City of Seattle

STANDARD SYMBOLS  
PRIVATE UTILITIES

STANDARD SYMBOLS  
WATER

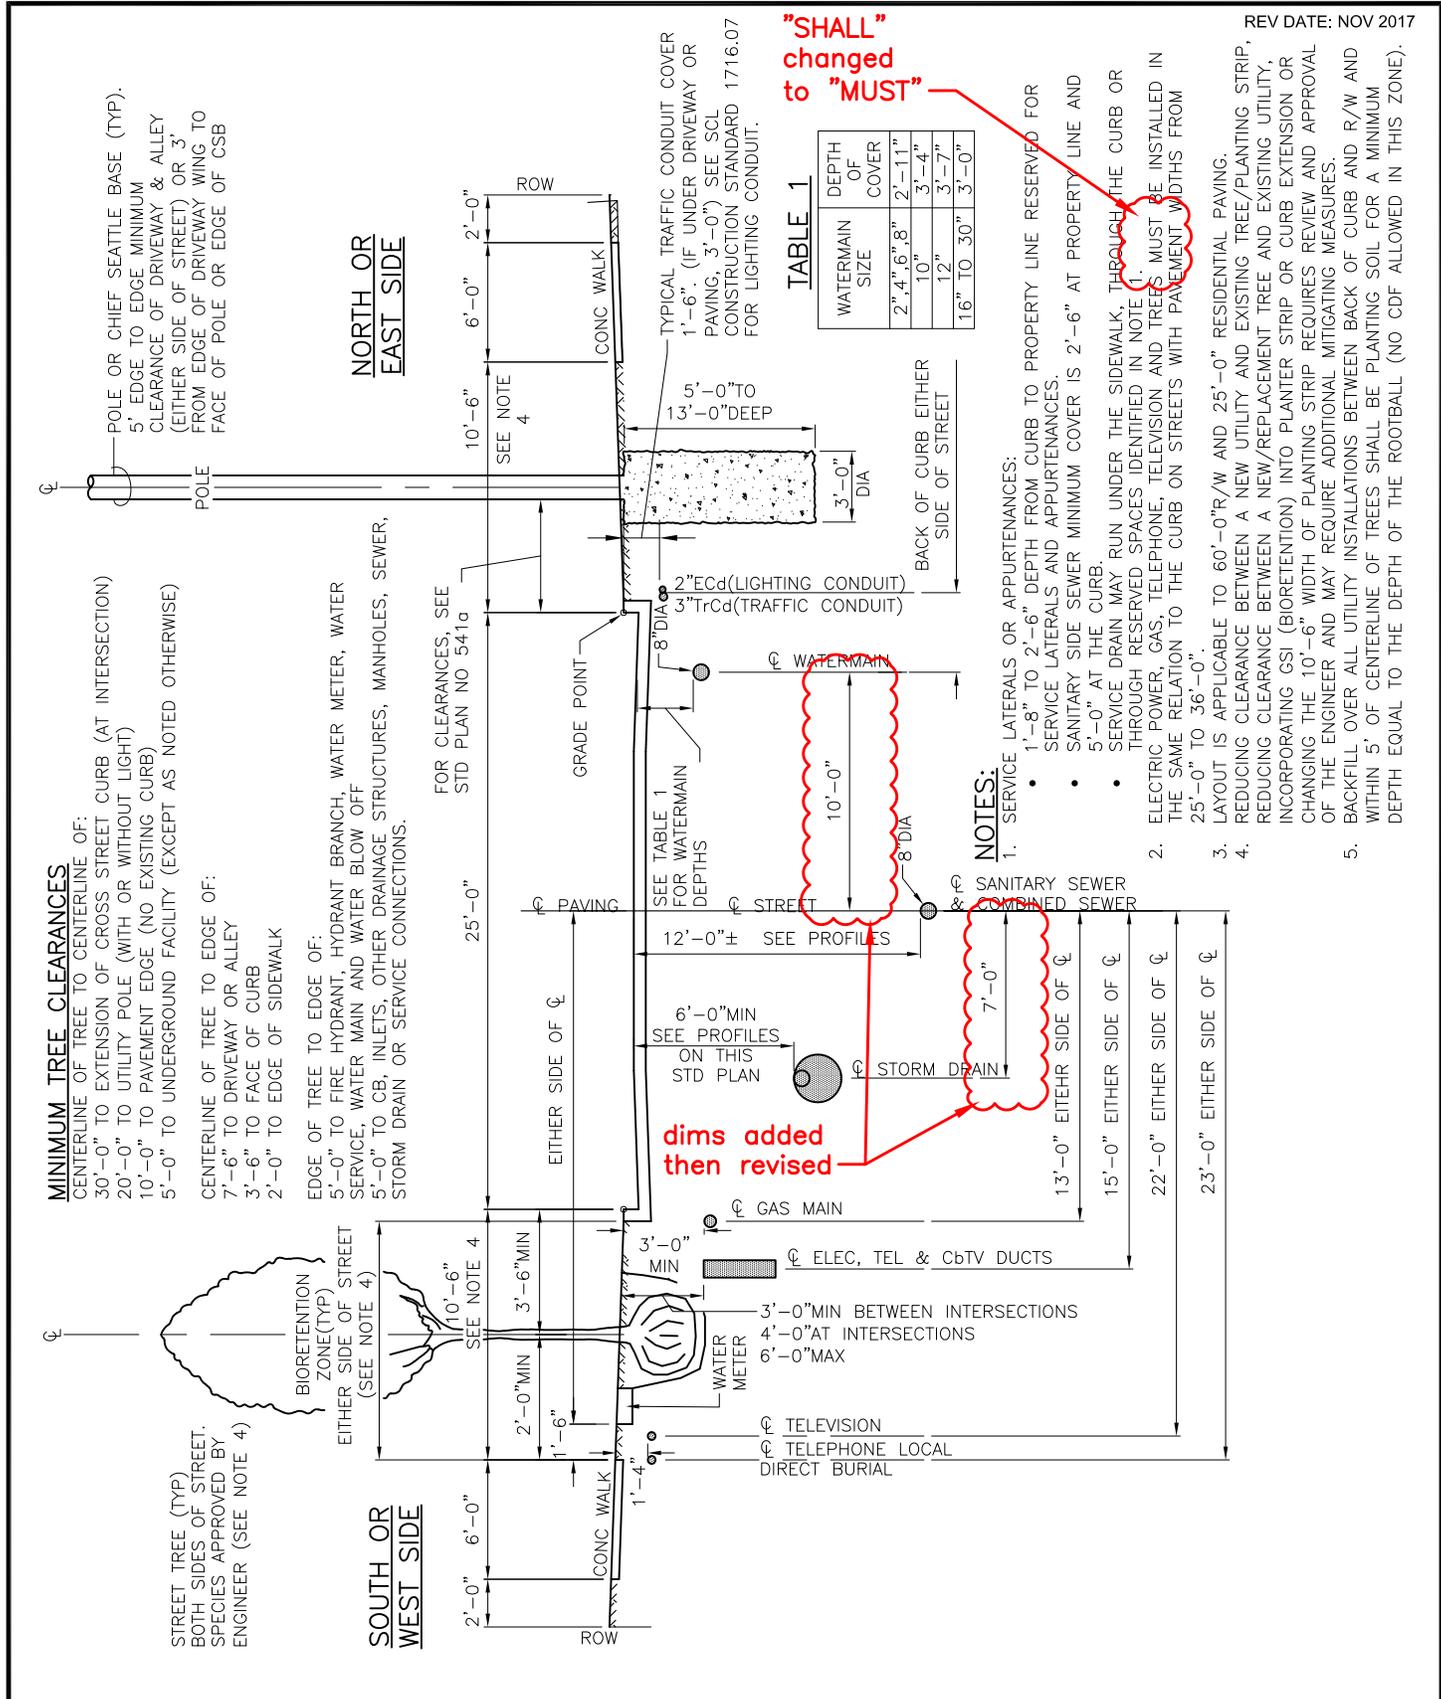
revised

revised

STABILIZED CONSTRUCTION ENTRANCE

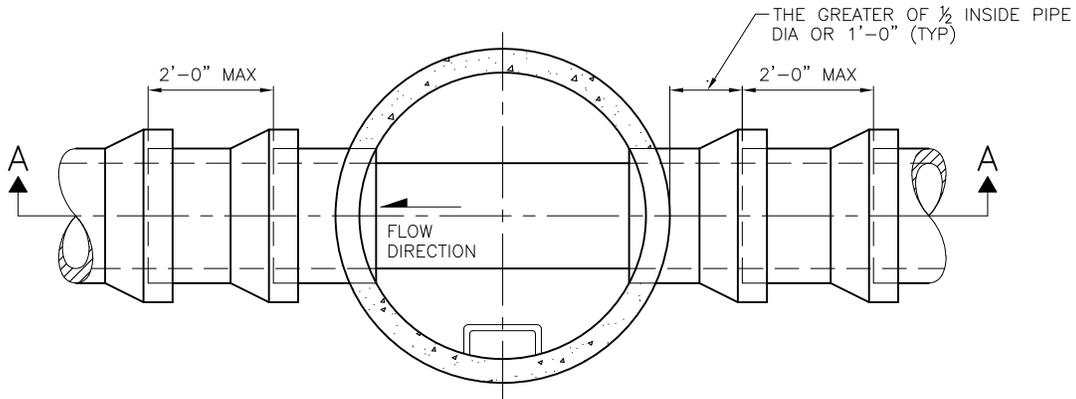
note 3 added

new standard plan

PVC SHEAR GATE  
FOR USE IN ROW ONLY

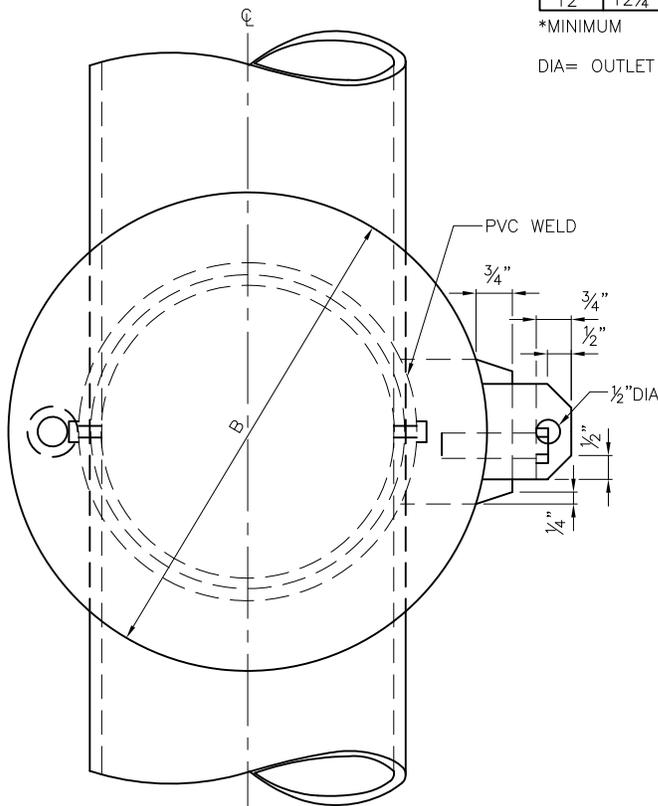
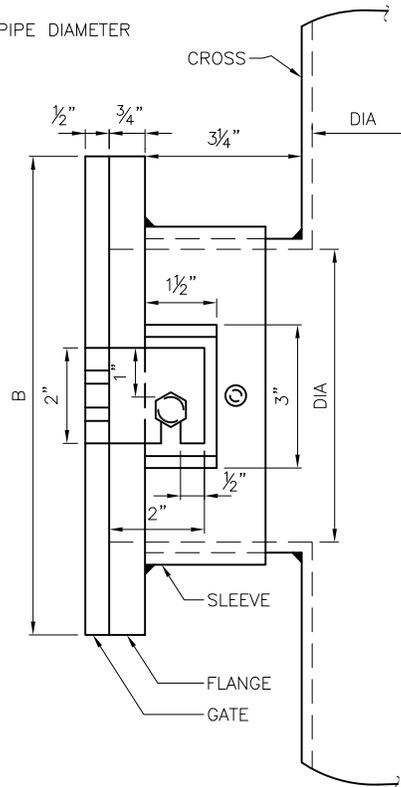
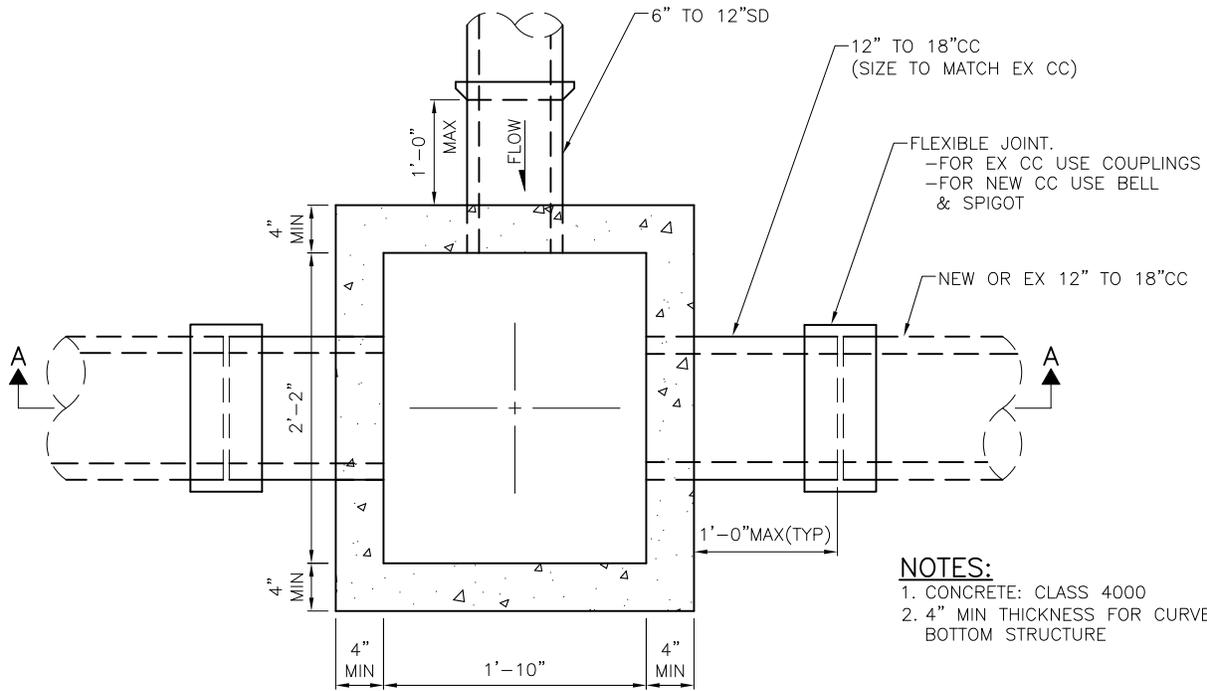
callout revised

**TYPE 277 JUNCTION BOX & INSTALLATION**

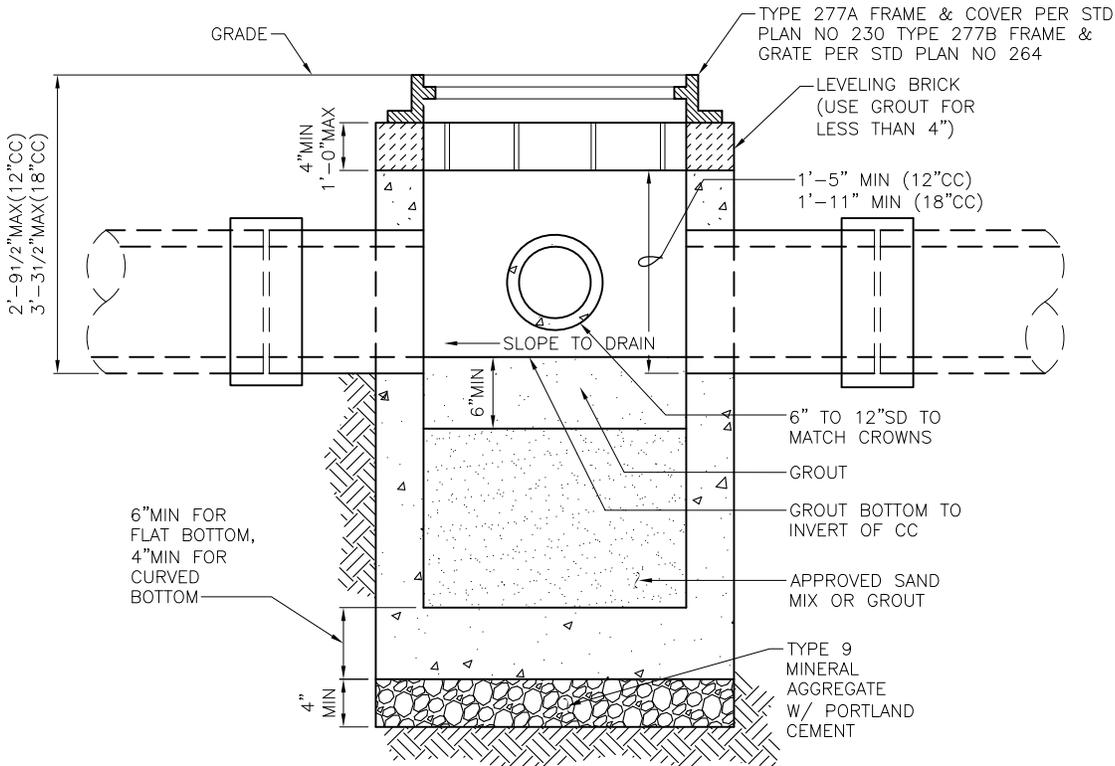
7-02, 9-12.9 revised

TEE INSTALLATION  
CORRUGATED METAL PIPE

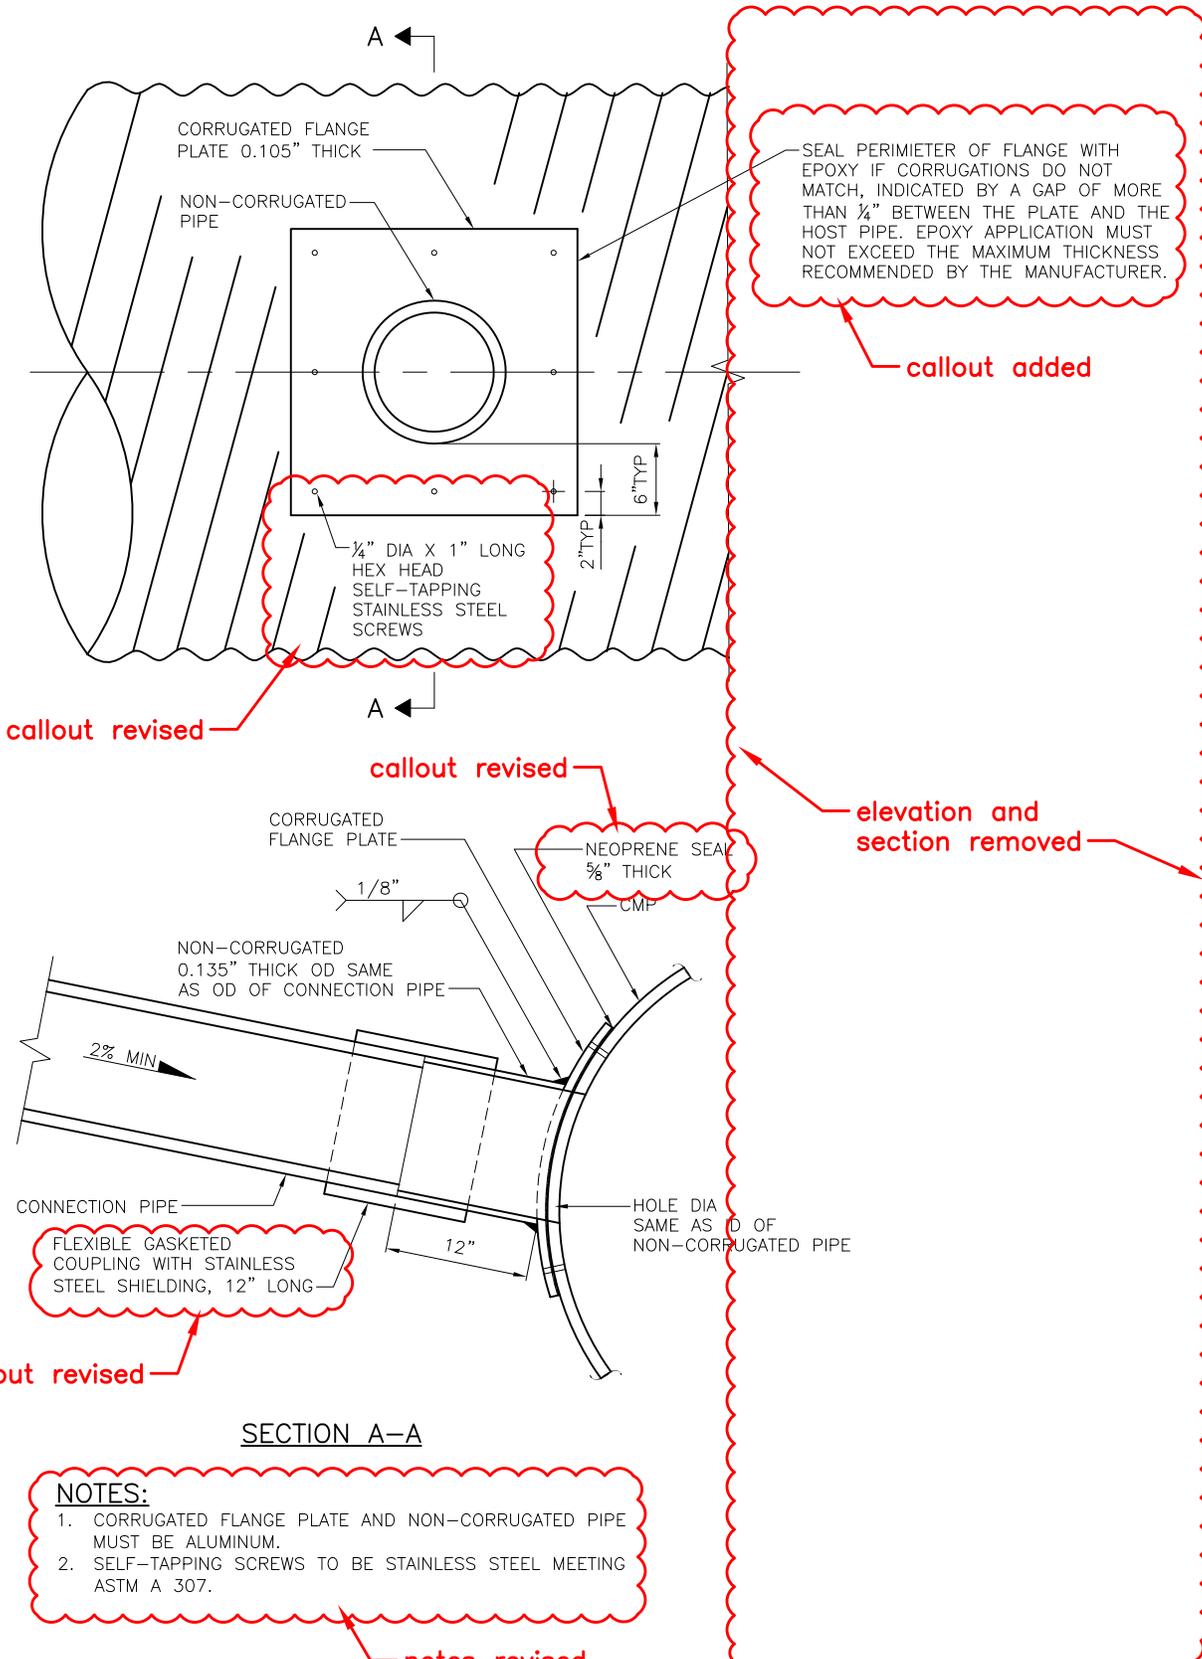
callout added

callout revised

callout revised

elevation and section removed

callout revised

notes revised

**PIPE BEDDING  
SEWER/STORM DRAIN**

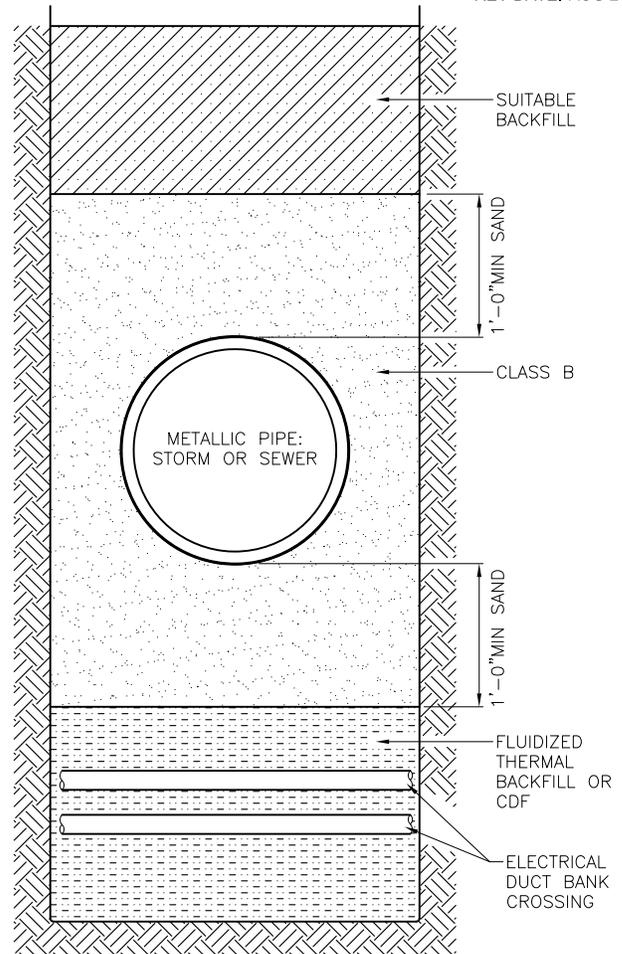
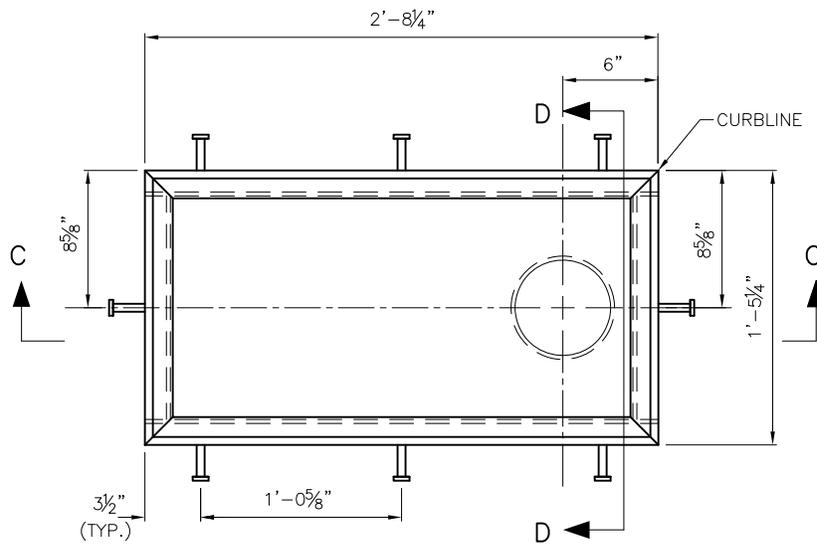
9-03.16 changed to 9-03.14

7-11 & 9-03.16 removed

BRIDGE DRAIN

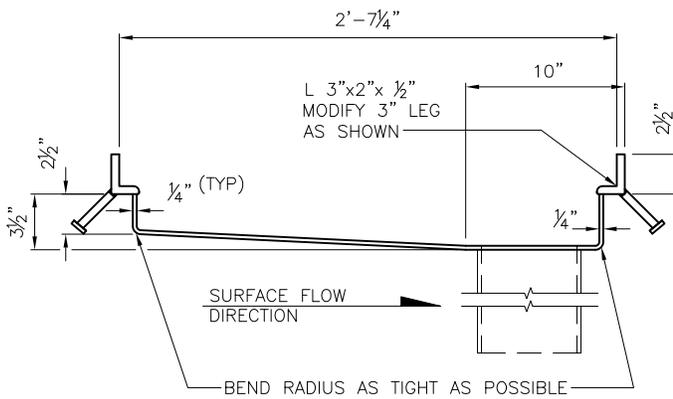
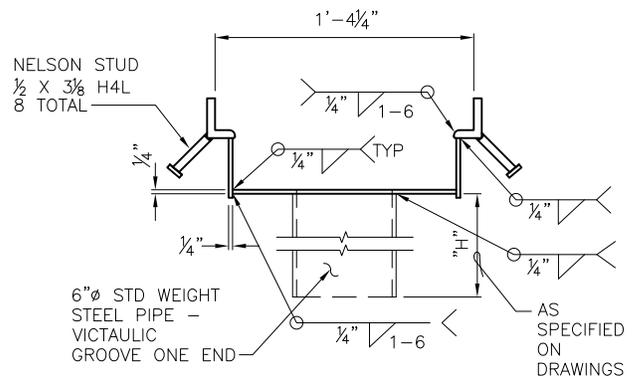
Delete this Standard Plan

CURB INLET FRAME

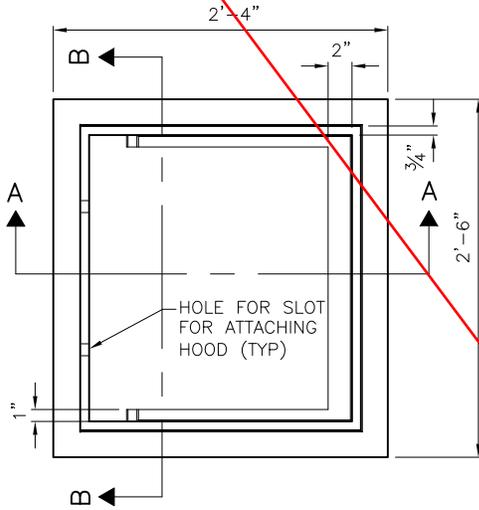
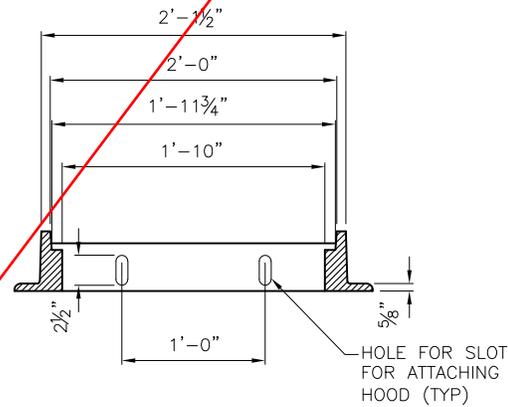
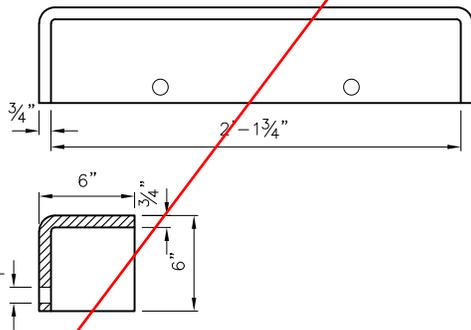
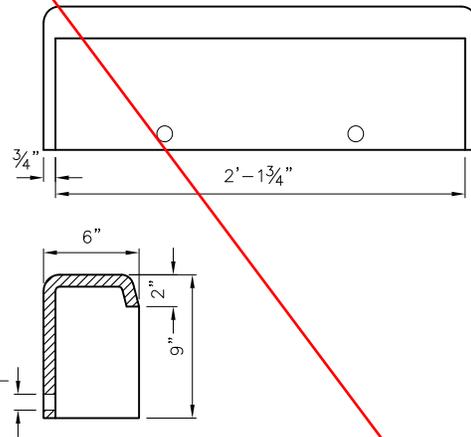
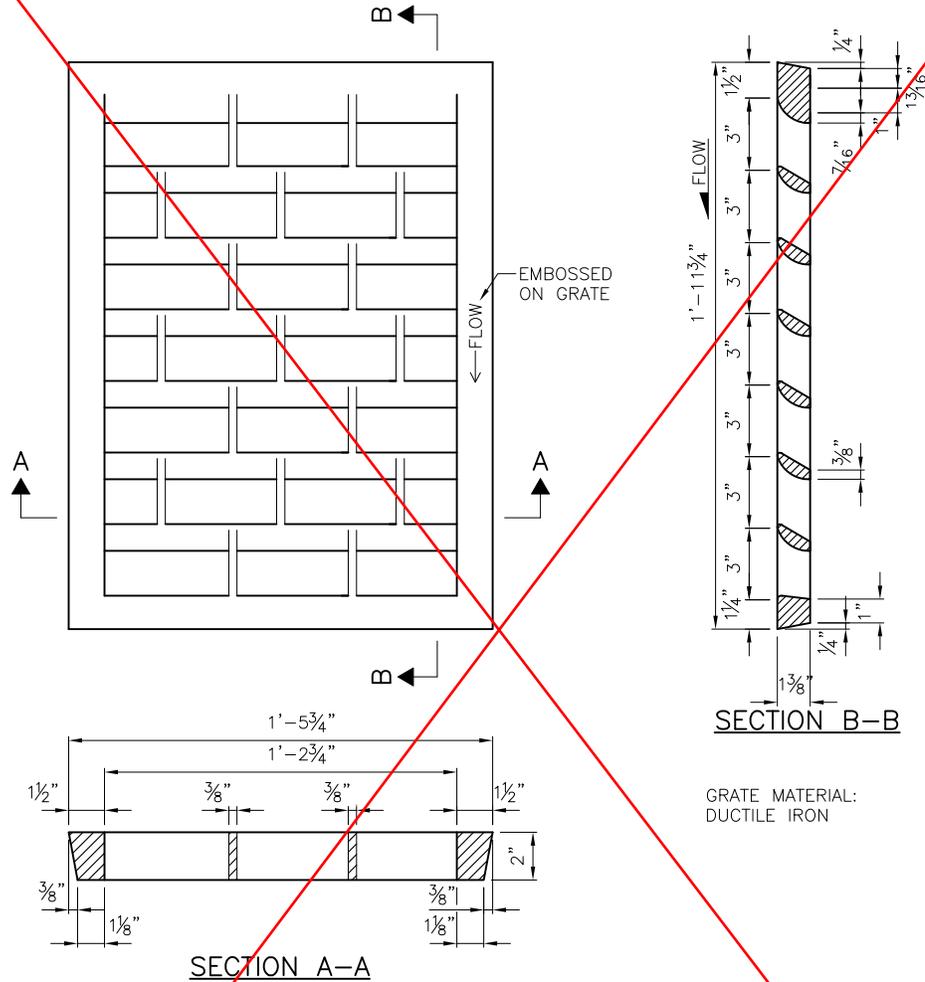
Delete this Standard Plan
